**SERVICE BULLETIN**  
**SB0721 Rev - June 15, 2022**

**Saft Battery Type 425CK1 (P/N 416392)**  
**Hamilton Sundstrand P/N 5915609-2**  
**Bombardier P/N C07500016-001)**

**Field Replacement of Cell P/N 024036-000**

**Figure 1 Mod-dot label marking**

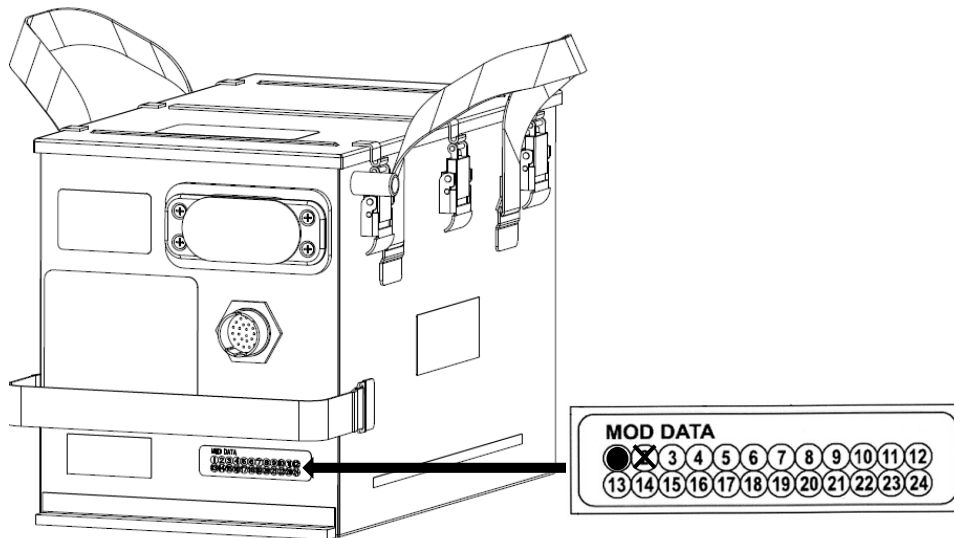
Step 17. Mark the mod-dot label as reflected in Figure 1 by permanently crossing out “2”.
